**ADDENDUM #3**

**TO CONTRACT DOCUMENTS FOR:** Project #CP221611 – Patient Care Tower -  
Radiology Expansion

**PREPARED FOR:** The Curators of the University of Missouri

BMCD project #:	143839	MU project / contract #:	CP221611
drawing	PD-122 - B	rev.

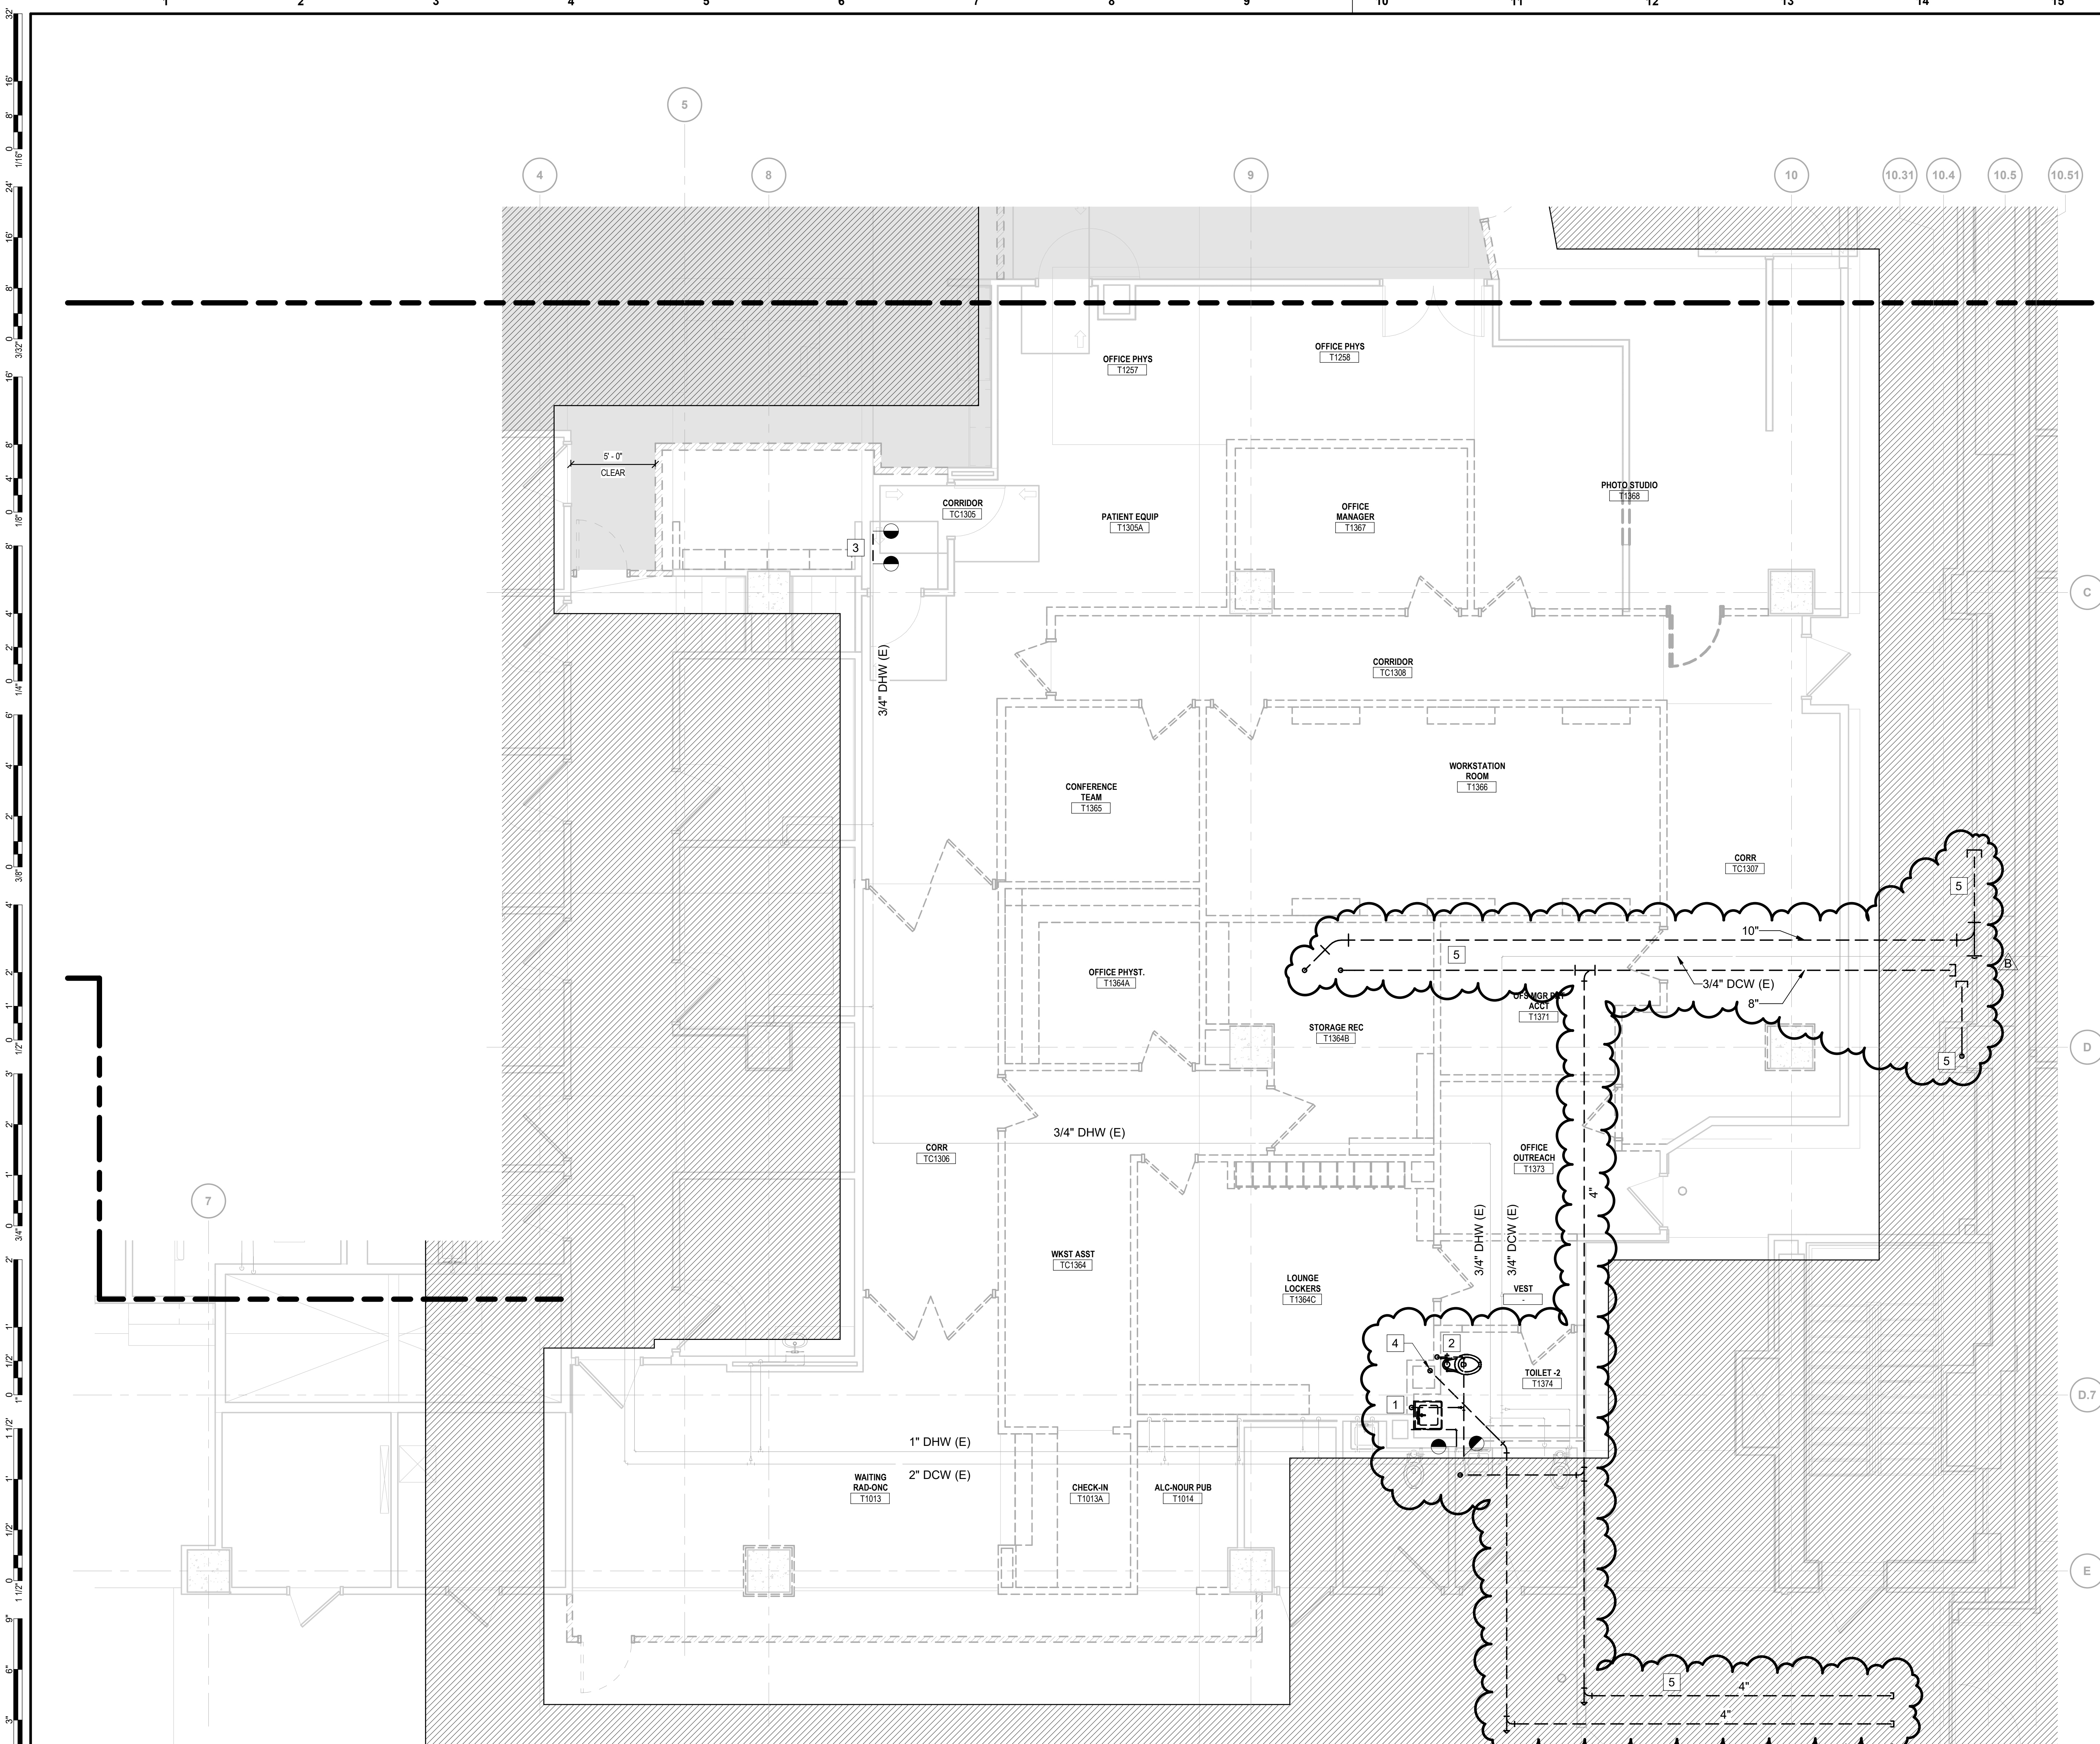
- 1) Mechanical Drawing MP-122-A: DPT location added.
- 2) Sketch: DP Monitor Detail attached.
- 3) Architectural Drawing A-123-A: Annotation plan keyed note 5 removed.
- 4) Piping Drawings PD-122-B: Additional piping demolition noted.
